# Access Compliance Report

## Public Rights-of-Way

### (Curb Ramps)

Intersection ID: 50042	Main Street: METROPOLITAN_AV	Cross Street: S_KINGS_DR	Location: W
ADA ID: 9C946ACABDC8	Ramp Type: Perp	Initial Pass/Fail: Fail	Overall Compliance: No
Severity Score: 22.5			
Codes/Mitigation Info/Possible Solution		Field Measurements/Component Compliance

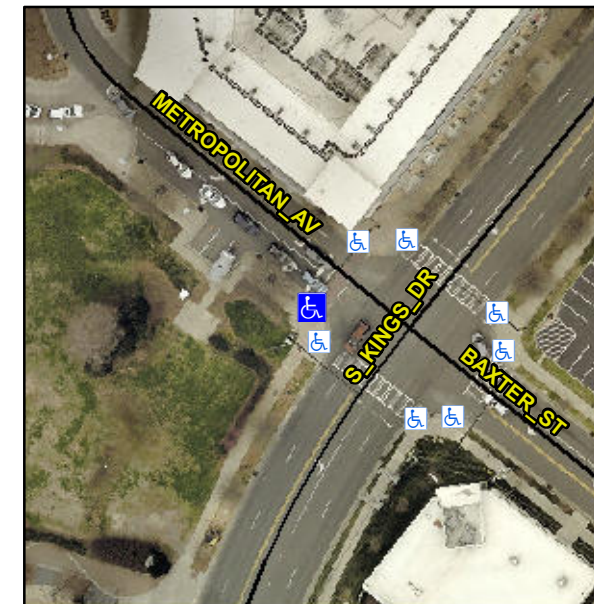
**R304.5.1, R304.2.2, R304.5.3**

Compliance	Description	Data	Compliance	Description	Data
N/A	Ramp Length (in)	48.0	No	Ramp Slope (%)	8.6
No	Ramp Width (in)	43.0	No	Ramp XSlope (%)	2.1
N/A	Flare Type LT	N/A	N/A	Flare Type RT	N/A
N/A	Flare Slope LT (%)	N/A	N/A	Flare Slope RT (%)	N/A
N/A	Flare Traversable LT?	N/A	N/A	Flare Traversable RT?	N/A
N/A	Landing Length (in)	N/A	N/A	DWS Provided?	N/A
N/A	Landing Width (in)	N/A	N/A	DWS Contrast?	N/A
N/A	Landing Slope (%)	N/A	N/A	DWS Length (in)	N/A
N/A	Landing X Slope (%)	N/A	N/A	DWS Full Width?	N/A
N/A	Landing Curb? (Y/N)	N/A	N/A	DWS Offset (in)	N/A
N/A	Shared Landing?	N/A			
N/A	Gutter Ponding?	N/A	N/A	Gutter Slope (%)	N/A
N/A	Gutter Lip Ht (in)	N/A	N/A	Gutter X Slope (%)	N/A
N/A	Painted X Walk1?	Yes	N/A	Painted X Walk2?	N/A
	X Walk 1 Direction	To NE		X Walk 2 Direction	N/A
N/A	X Walk 1 Width (in)	112.0	N/A	X Walk 2 Width (in)	N/A
	X Walk 1 Slope (%)	2.6		X Walk 2 Slope (%)	N/A
	X Walk 1 X Slope (%)	0.5		X Walk 2 X Slope (%)	N/A

**Remove & Replace Entire Ramp.**
